CHRYSLER A604 (41TE) UPDATE HANDBOOK

*Updated
May, 2003*

"UPDATE HANDBOOK"

Figure 43

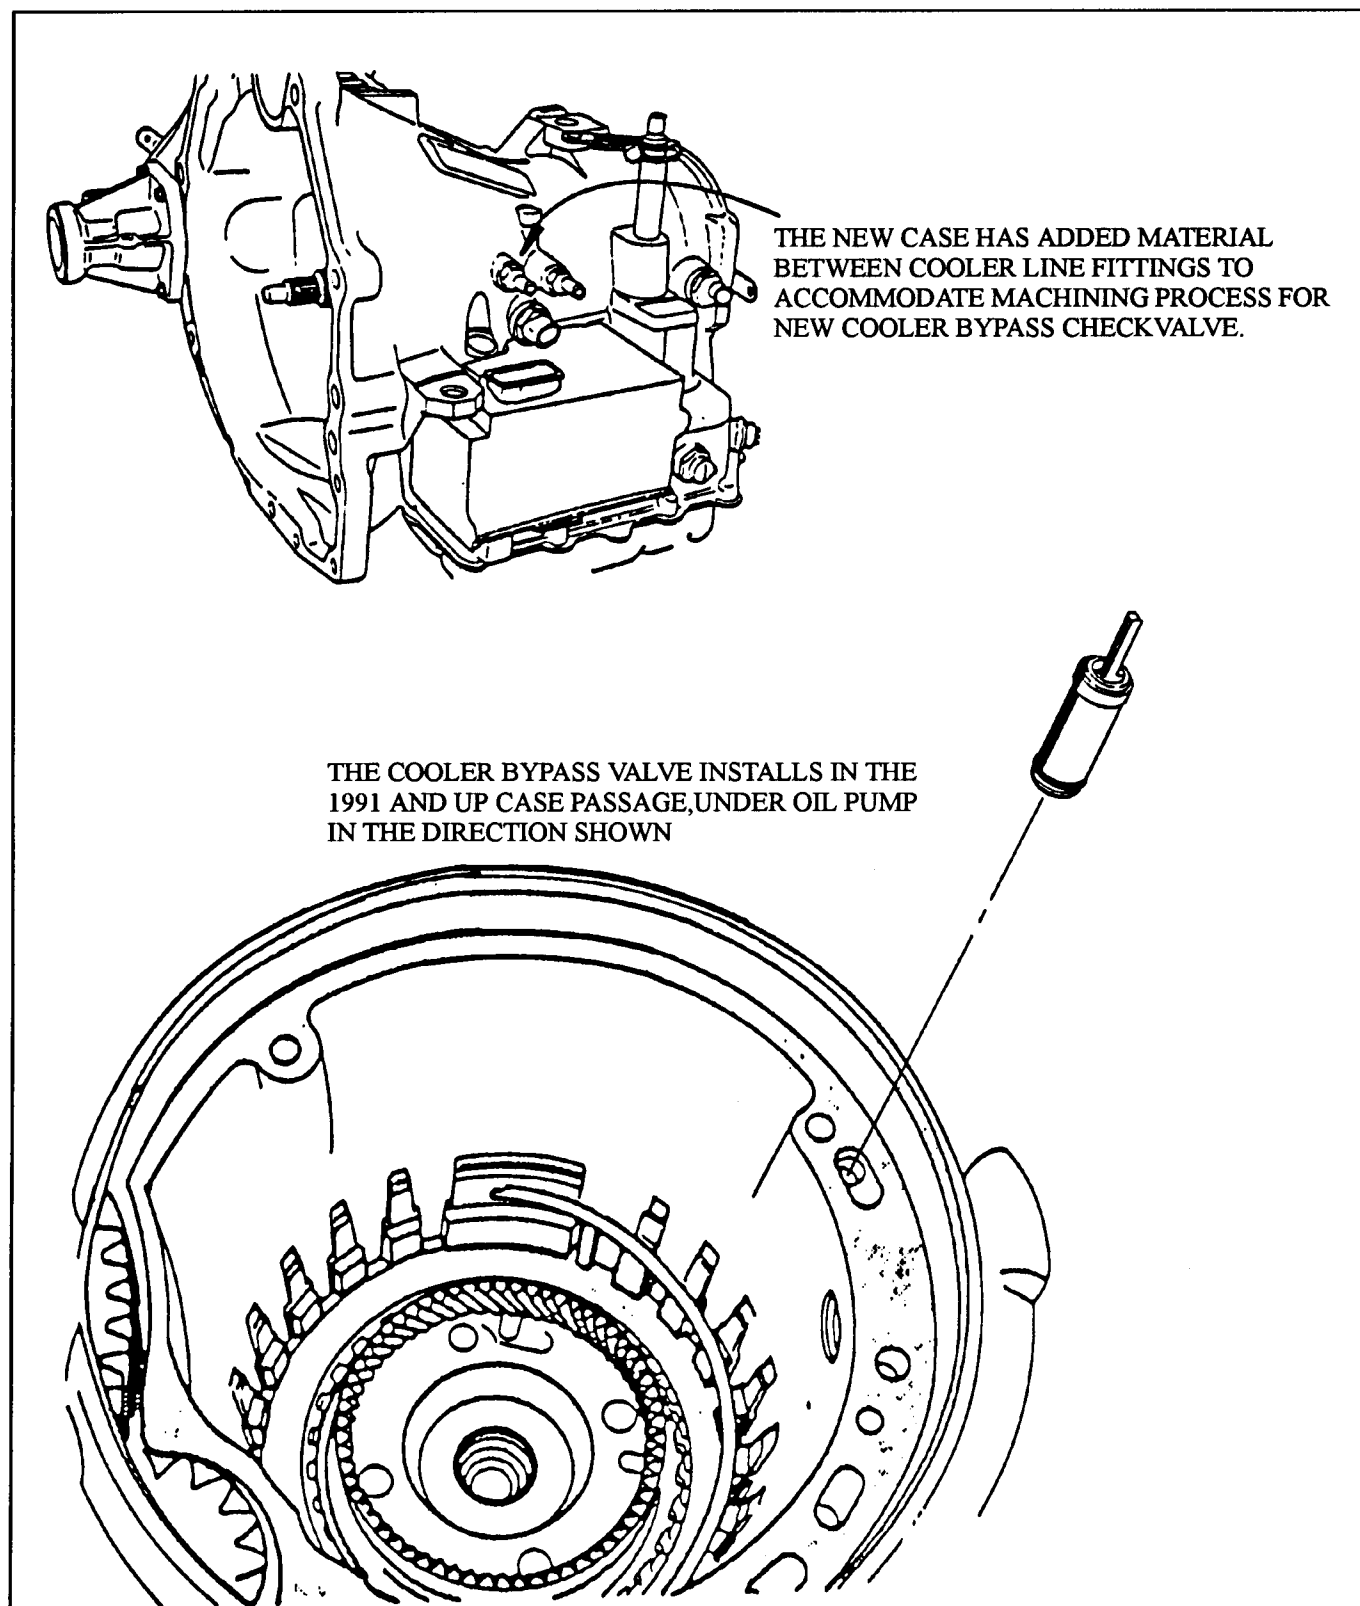
CHANGE: Beginning in 1991 model A604 transaxles, there has been a "Cooler Bypass Check Valve Assembly" added in the transaxle case behind the oil pump. (See Figures 42 and 43).

- (1) **COOLER BYPASS CHECK VALVE** - added into the case cooler passage behind the oil pump (See Figure 43). If cooler oil flow is restricted, or blocked, the new check valve will open, and allow cooler feed oil direct into the lube circuit to prevent transaxle damage. Normal operation is resumed after oil temperature is warm enough to again flow through the cooler. (See Figure 42).
NOTE: Customers should be advised to let the vehicle warm-up thoroughly before attempting to drive the vehicle, especially in the colder climates.
- (2) **TRANSAXLE CASE** - The new case has added material between the two cooler line fittings, to accommodate the machining process needed for the new cooler bypass check valve assembly (See Figure 43).
- (3) **VALVE BODY SPACER PLATE** - Lube feed hole in spacer plate has been enlarged to .112", as shown in Figure 44.

Figure 44

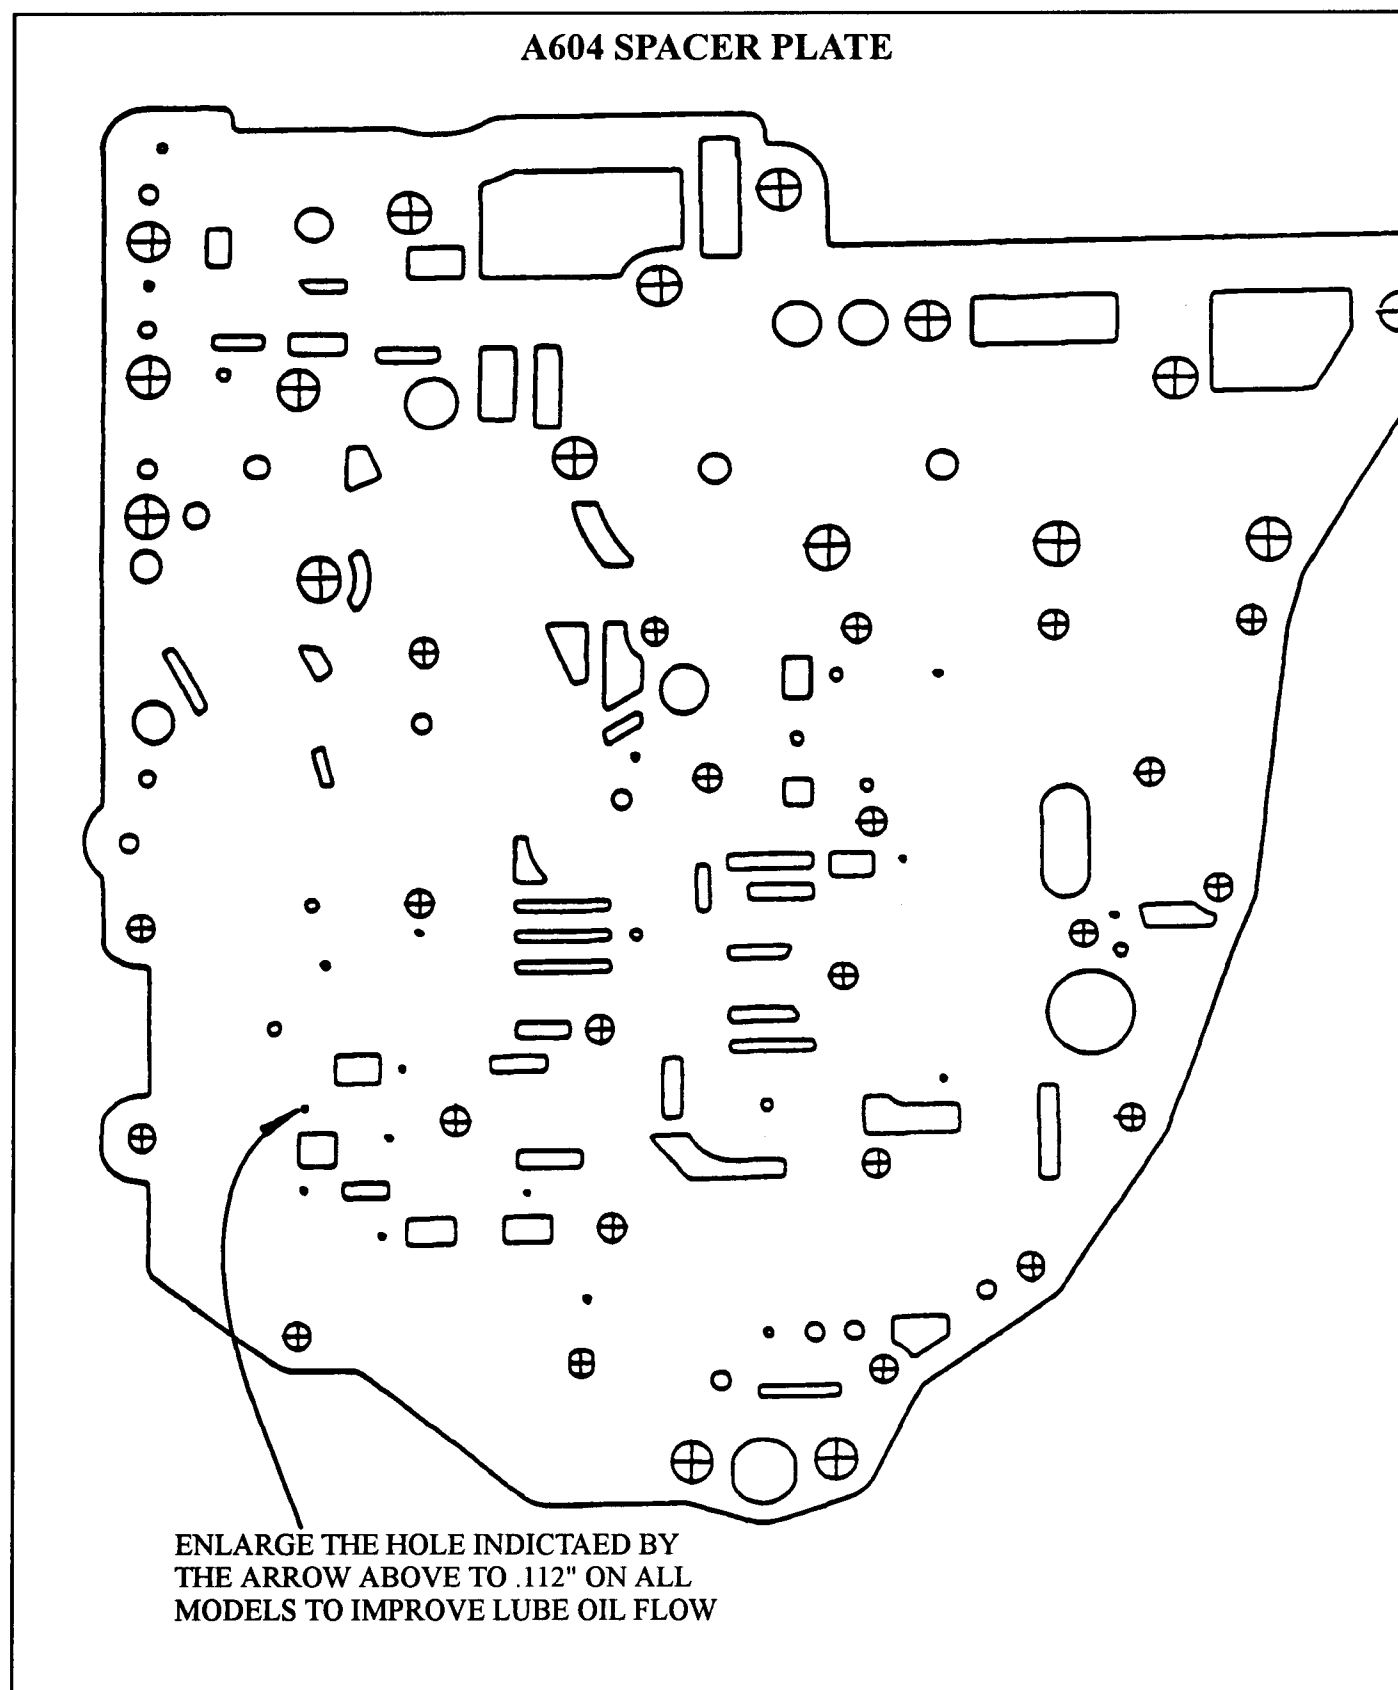
Cooler bypass check valve assembly "WILL NOT" retrofit back to previous models, unless the new transaxle case is installed at the same time. The lube feed hole in the spacer plate can be drilled to .112" on all models to improve lube oil flow (See Figure 44).

Figure 60

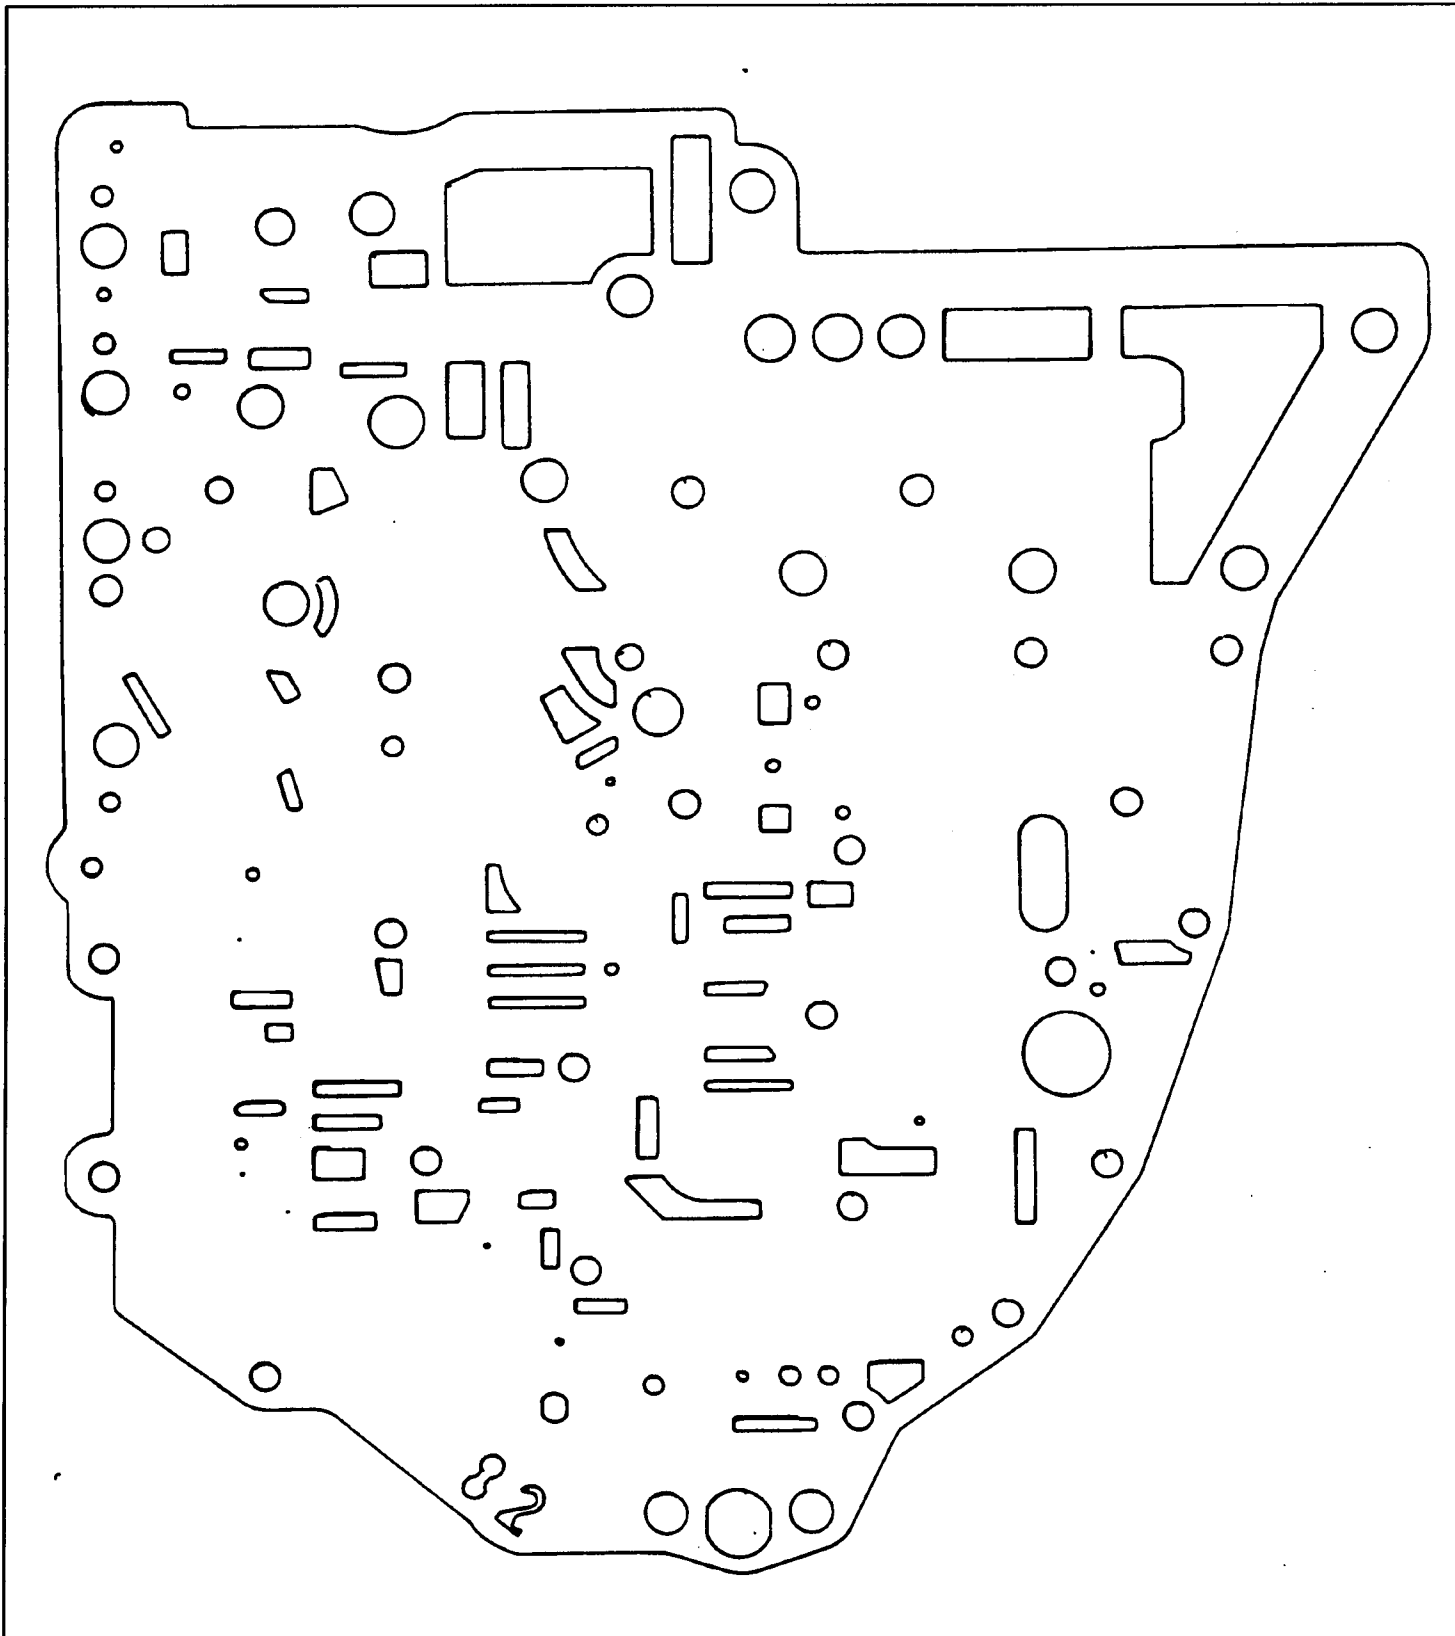
CHANGE : A running change in 1994 was made to the spacer plate (See Figure 60) and to the Pressure Regulator Valve (See Figure 61).

Figure 62

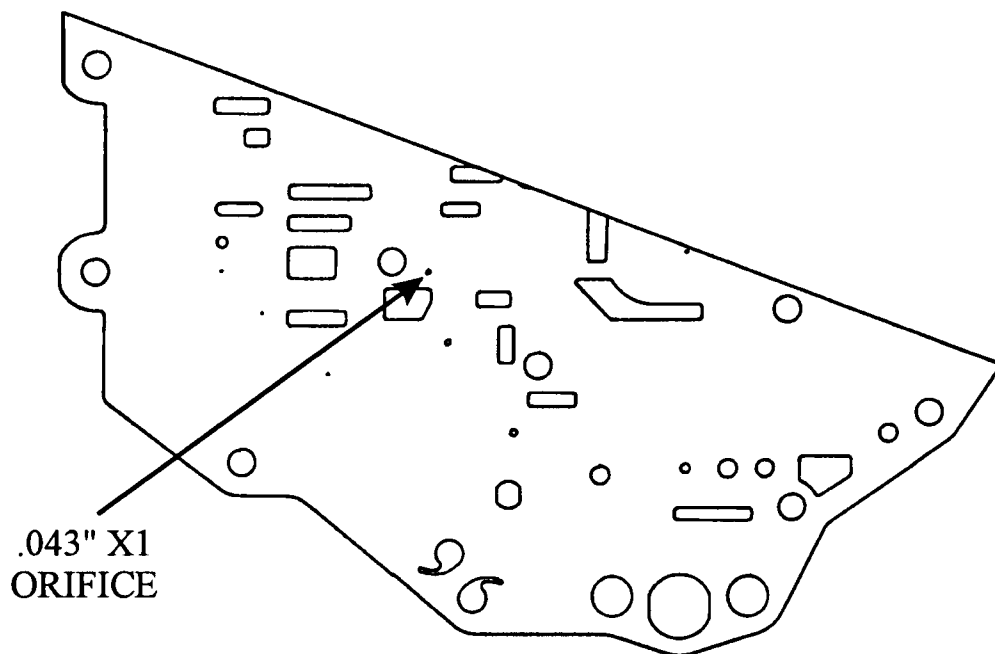
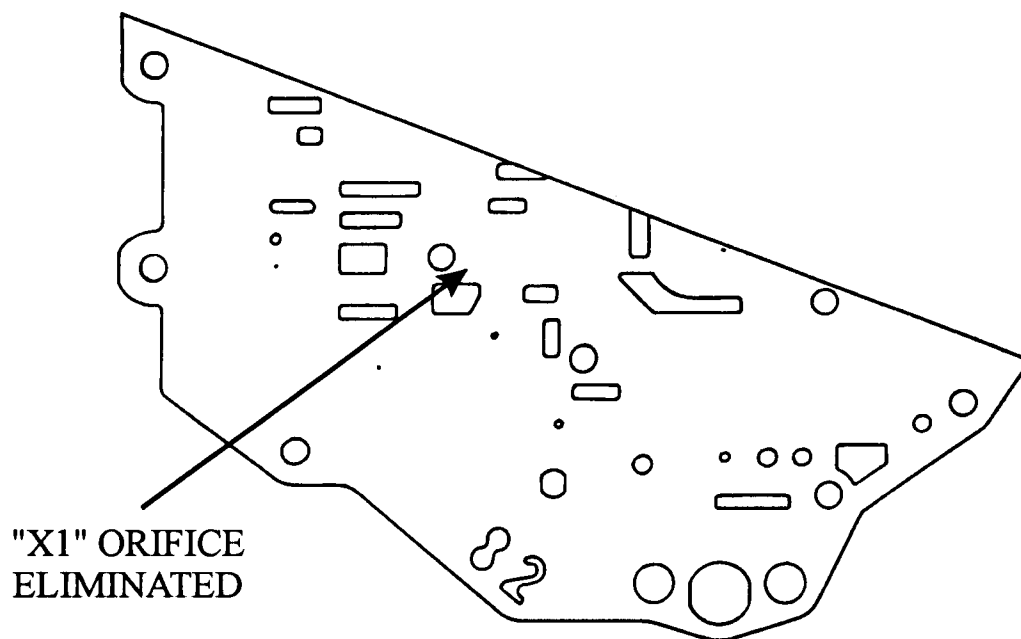
- (1) : **SPACER PLATE:** The "X1 Orifice" in the spacer plate has been eliminated as shown in figure 62. The plate can be easily identified by the number "82" that is punched through the plate (See Figure 62).
- (2) : **PRESSURE REGULATOR VALVE:** A ground step has been machined to the inner land on the Pressure Regulator Valve causing two different diameters to exist on one land (See Figure 63). There are no obvious or visible signs or identification marks to indicate the updated Pressure Regulator Valve. Careful measurement of the valve land is needed to properly identify the valve (See Figure 63). The spring side of the land measures approximately .6255". The opposite end of the same land will measure approximately .6245" (See Figure 63).

PREVIOUS # 96 SPACER PLATE WITH THE "X1" (.042") ORIFICE

NEW # 82 SPACER PLATE WITH THE "X1" ORIFICE ELIMINATED

The new "82" spacer plate replaces the previous "96" spacer plate and can retrofit back to all valve bodies and Transfer Plates that use the # 96 spacer plate **provided that the new pressure regulator valve is used together with the # 82 spacer plate.** Valve bodies that use a 96 spacer plate has a casting number of 4511644 (See Figure 52 on Page 68). Transfer Plates that use the # 96 spacer plate has a casting number of 4511645 (See Figure 54 on Page 70).

Figure 64

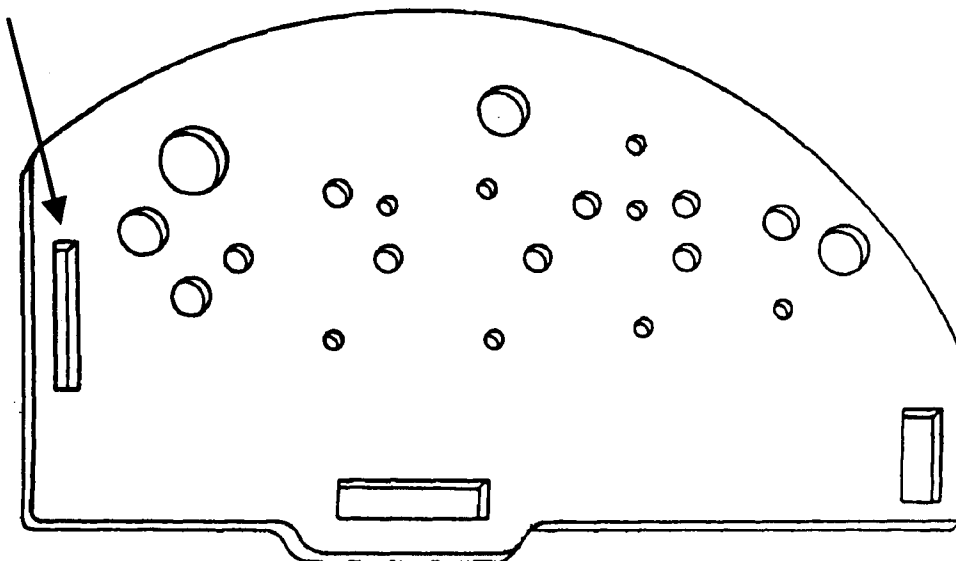
CHANGE : A running change for 1994 and all 1995 and up model years was made to the solenoid sound cover and spacer plate (See Figure 64).

- (1): **SOLENOID SOUND COVER** - An additional locking tab was added to the sound cover for a more secure fit to the solenoid spacer plate.
- (2): **SOLENOID SPACER PLATE** - The solenoid spacer plate received an added slot to accommodate the additional locking tab made to the solenoid sound cover. There were also subtle changes made to the venting holes and slots found in the spacer plate (See Figure 64).

**SLOT FOR LOCKING
TAB ADDED HERE**

Figure 65

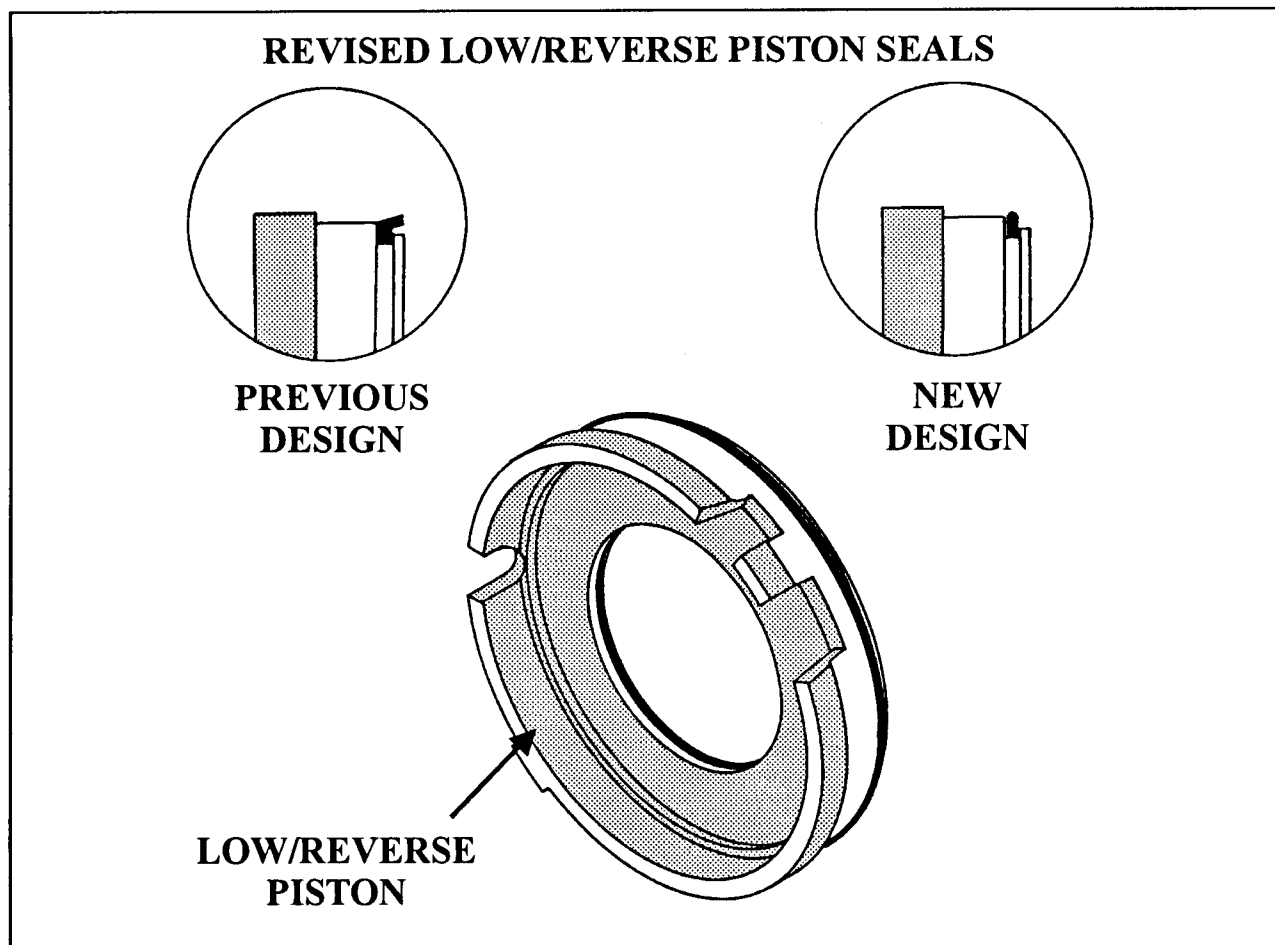
CHANGE: Beginning at the start of production for 1995 model year, all Chrysler A604 (41TE) and A606 (42LE) transaxles were produced using revised seals for the Low/Reverse piston. The previous "Lip" type seals have been replaced by a "D" Ring type seal for both inner and outer seals, as shown in Figure 65.

- (1) **LOW/REVERSE PISTON SEALS** - Both the inner and outer lip seals have been replaced by a "D" Ring type seal, as shown in Figure 65. There were no dimensional changes necessary to the Low/Reverse piston to accommodate the new "D" Ring seals. The seals are available under OEM part number 4659185 for the outer seal, and 4659184 for the inner seal.
